**SHINE MEDICAL TECHNOLOGIES, LLC OPERATING LICENSE APPLICATION
SUPPLEMENT NO. 2**

**FINAL SAFETY ANALYSIS REPORT CHANGE SUMMARY
PUBLIC VERSION**

FINAL SAFETY ANALYSIS REPORT MARKUP

Figure 7.4-1 – TRPS Logic Diagrams
(Sheet 1 of 13)

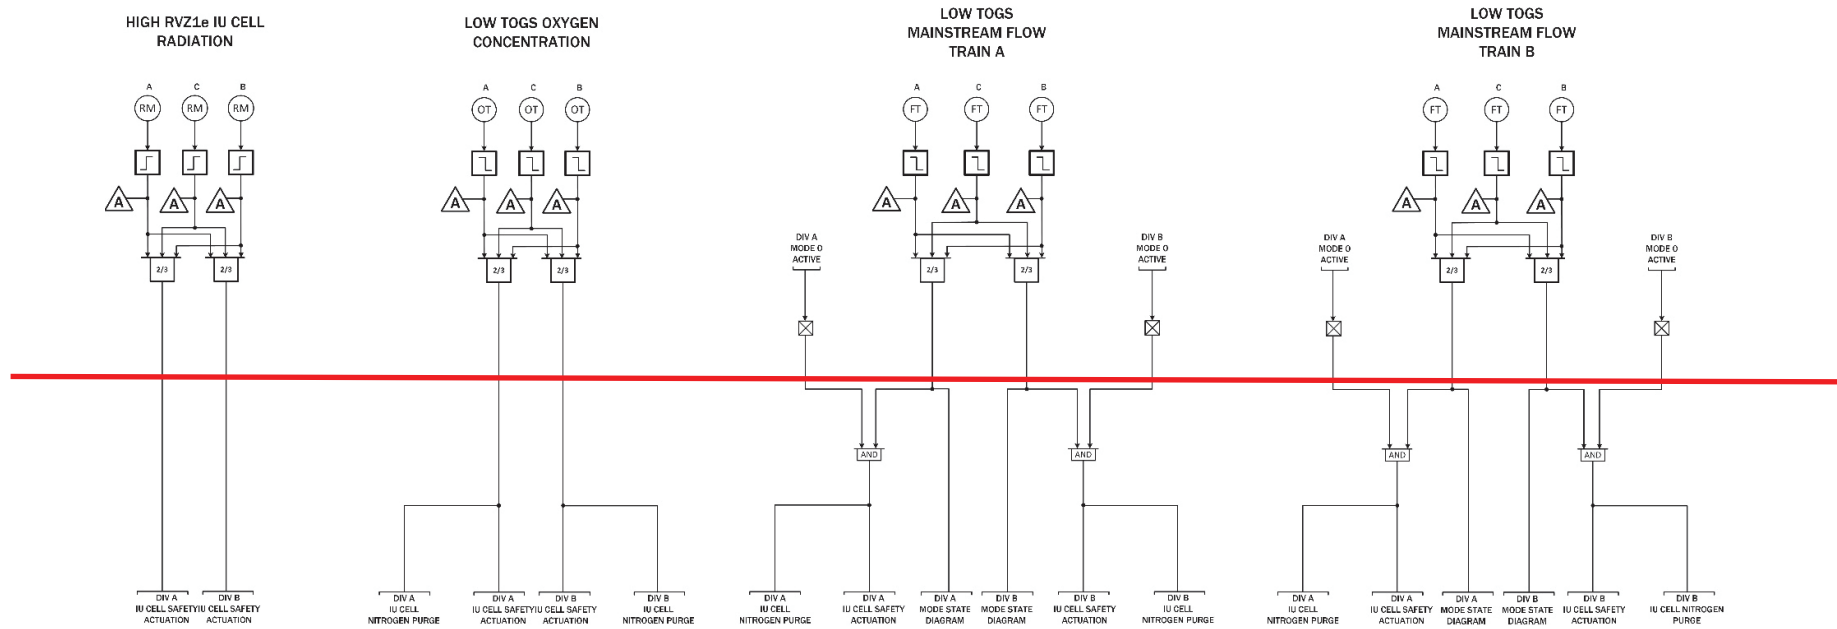
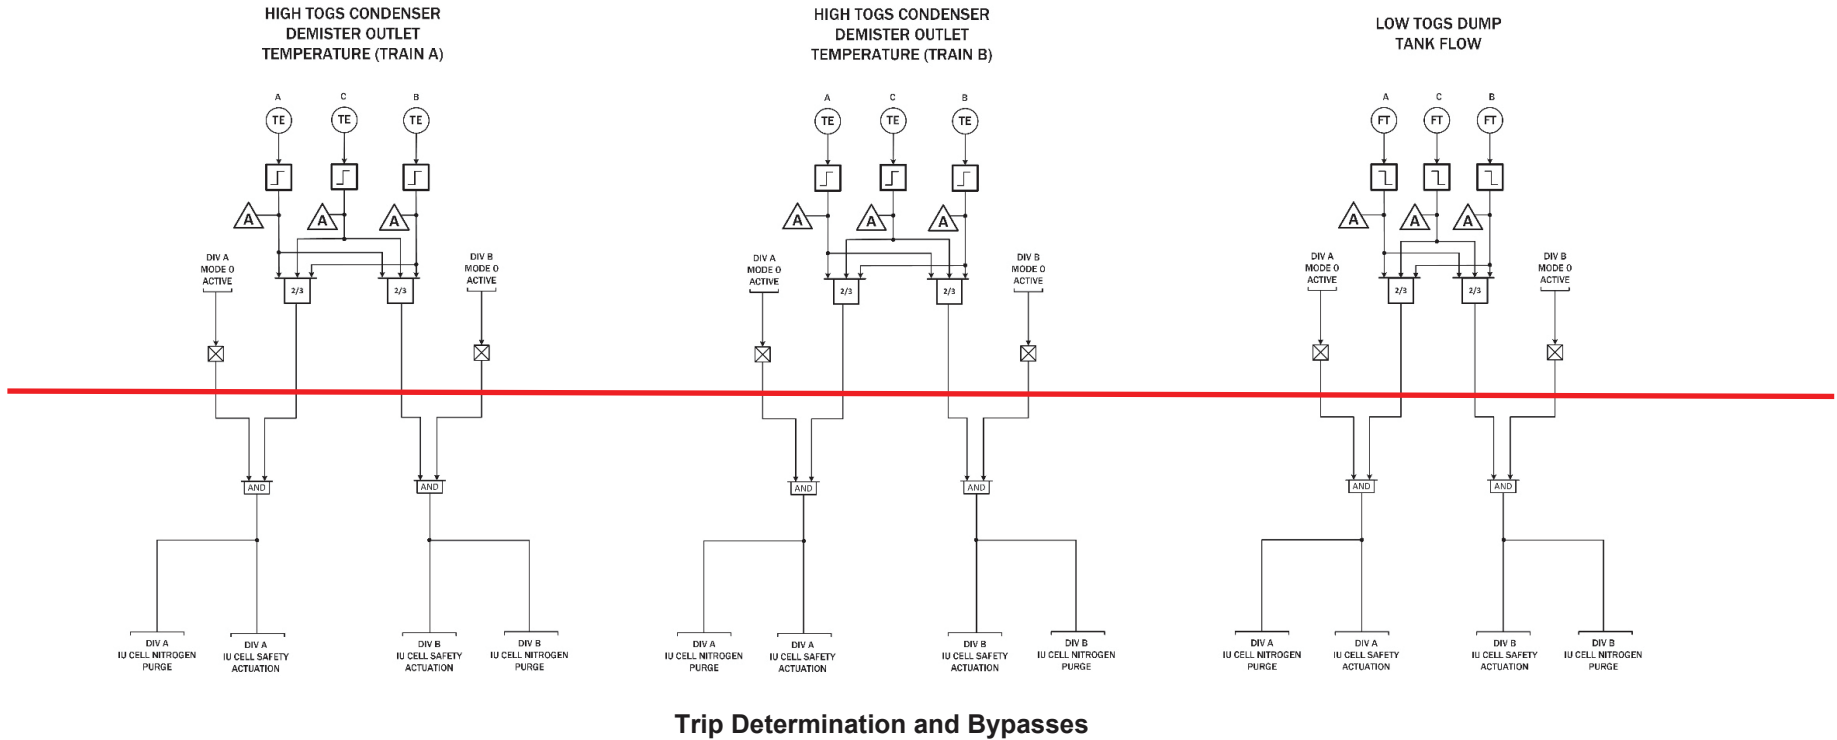
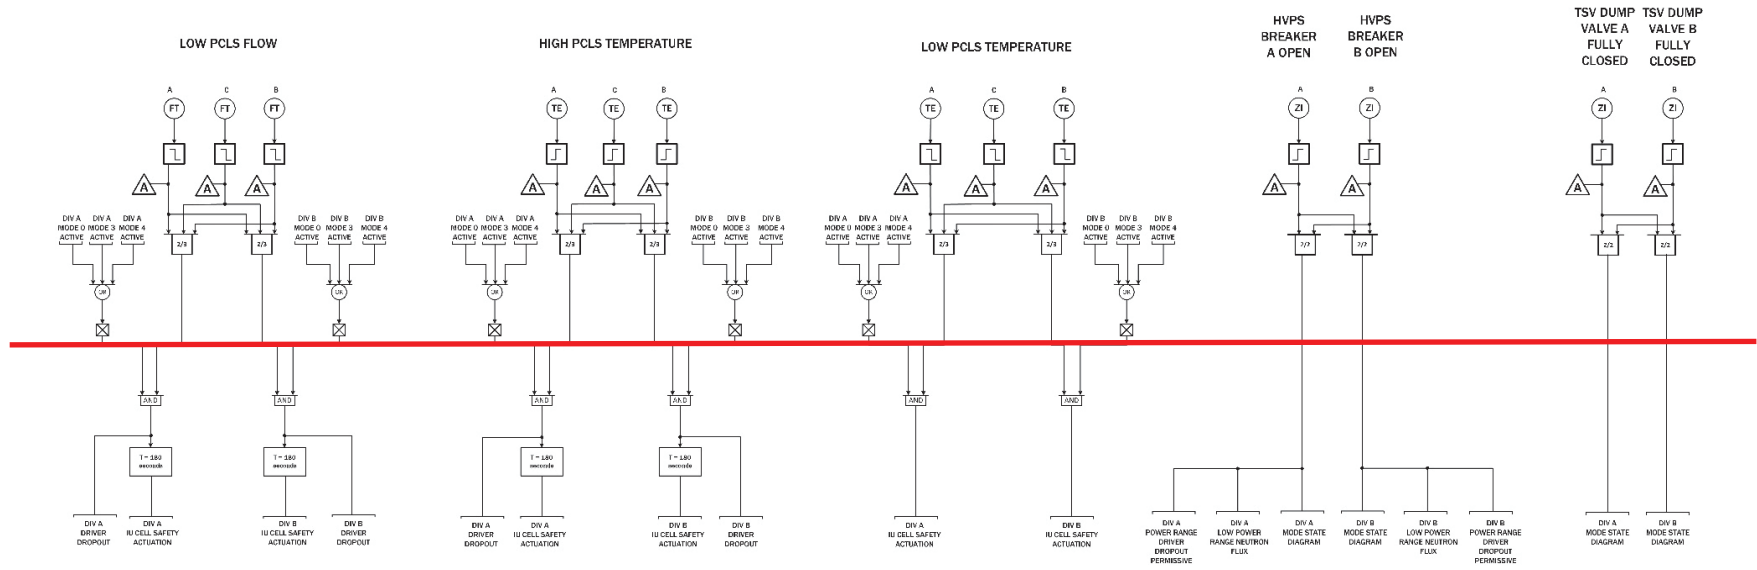
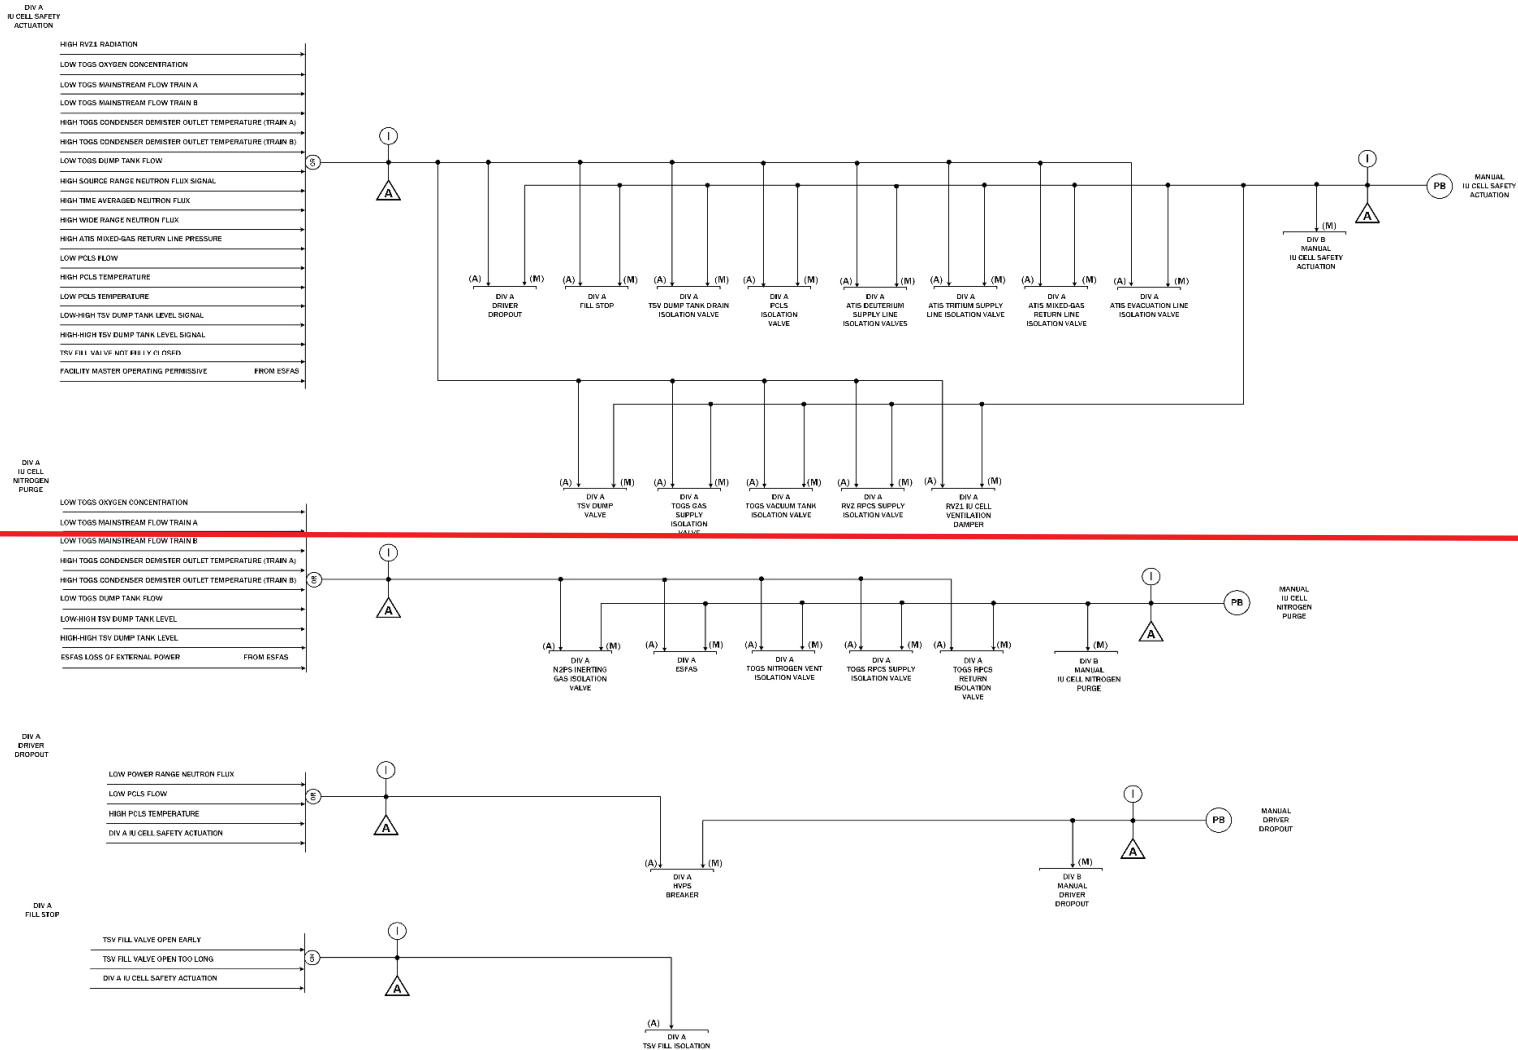
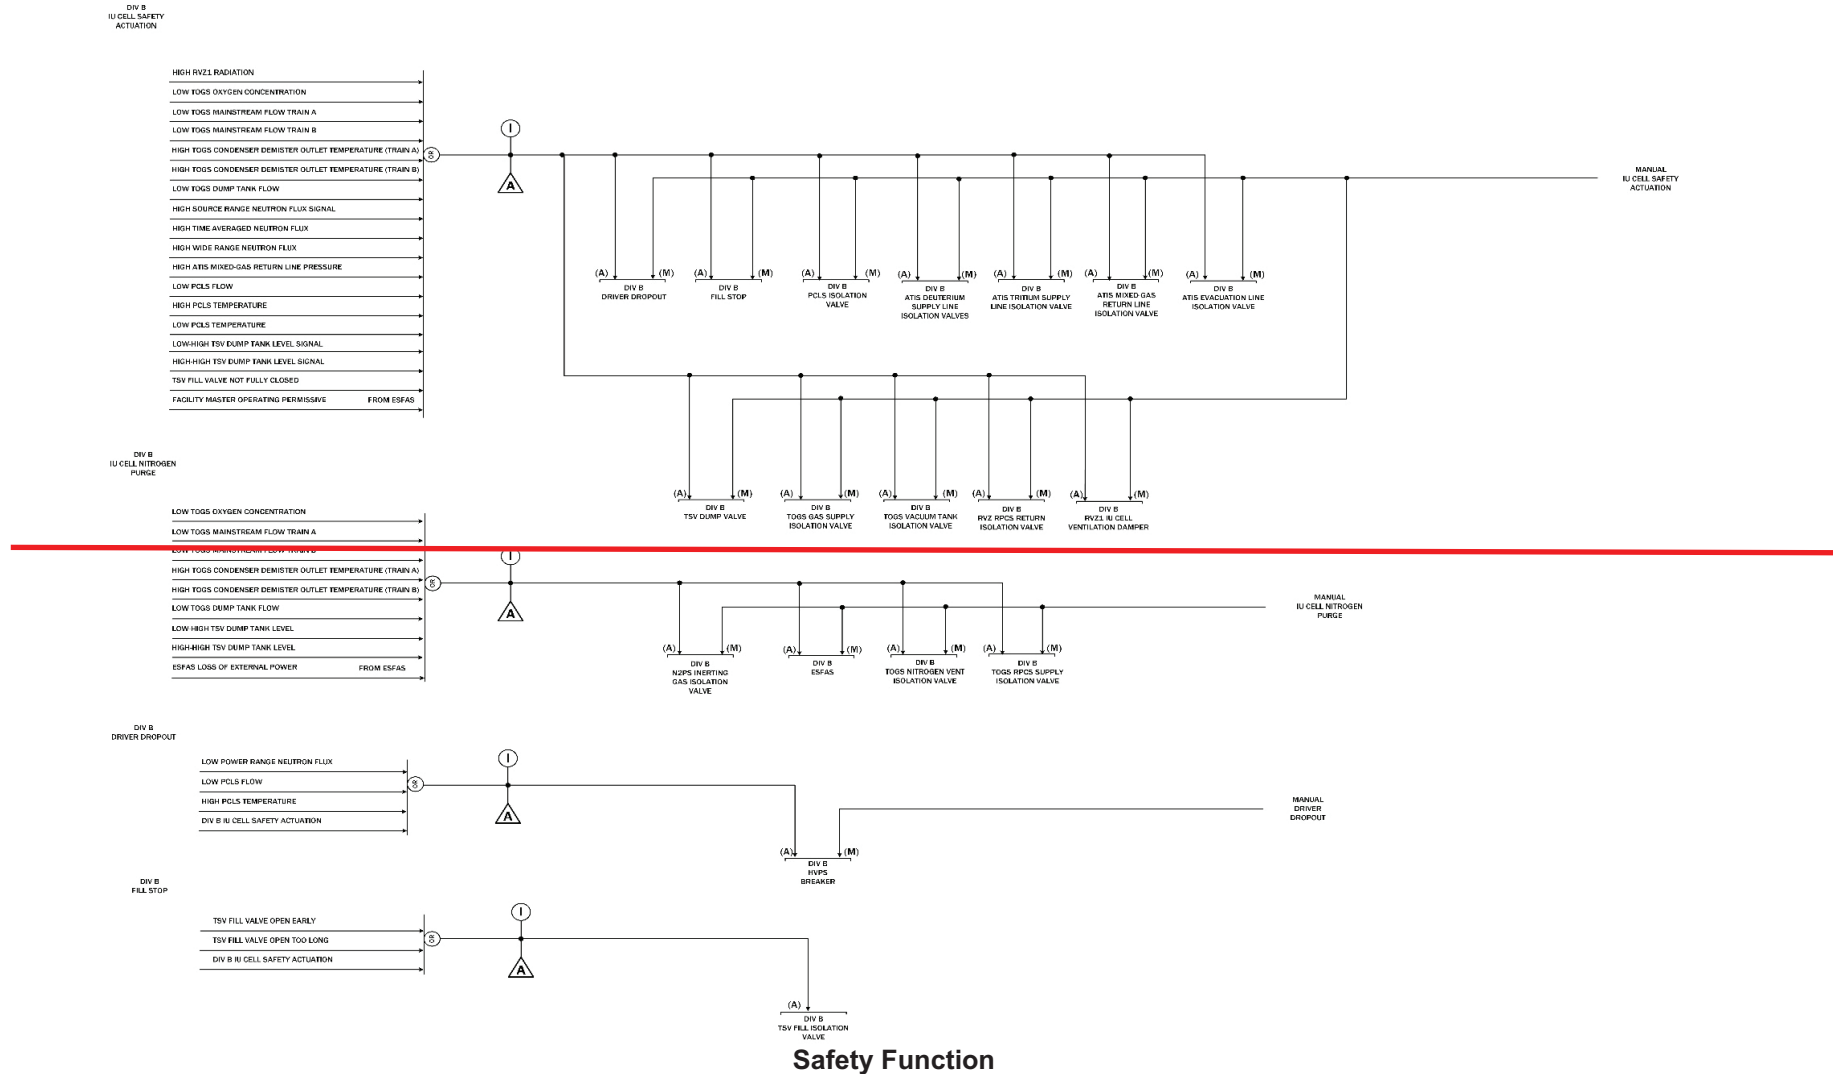
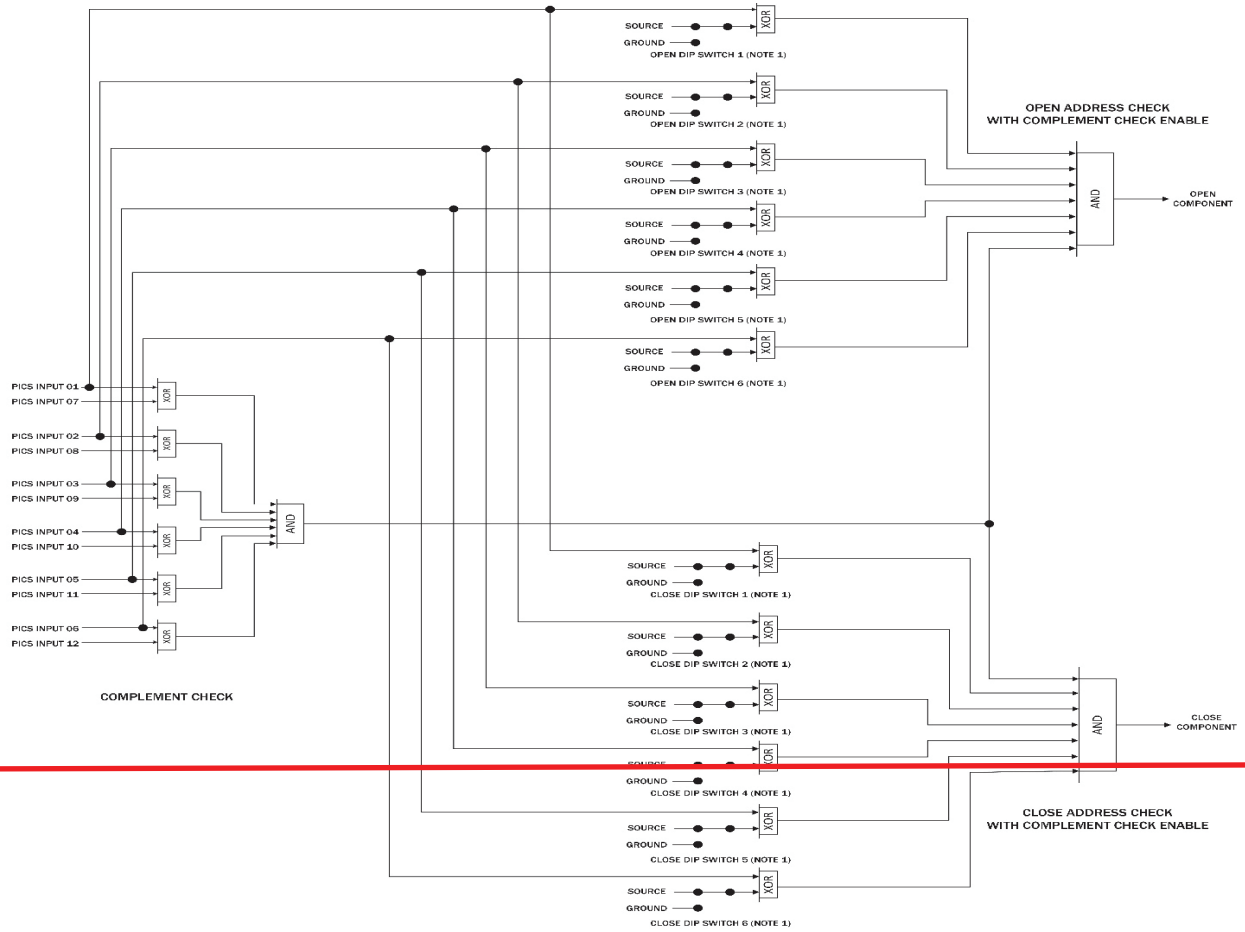
<p>Update to incorporate primary closed loop cooling system (PCLS) design changes. The PCLS design has been updated to incorporate SHINE design criteria 34, confinement isolation. This change improves the reliability of PCLS isolation safety functions.</p>	<p>Table 3.1-1, Section 5a2.2, Figure 5a2.2-1, Section 7.4, Figure 7.4-1</p>

~~Figure 7.4-1, Sheet 11 and Sheet 12,~~ shows how the TRPS latches in a protective action and maintains the state of a protective action until operator input is initiated to reset the output of the TRPS.
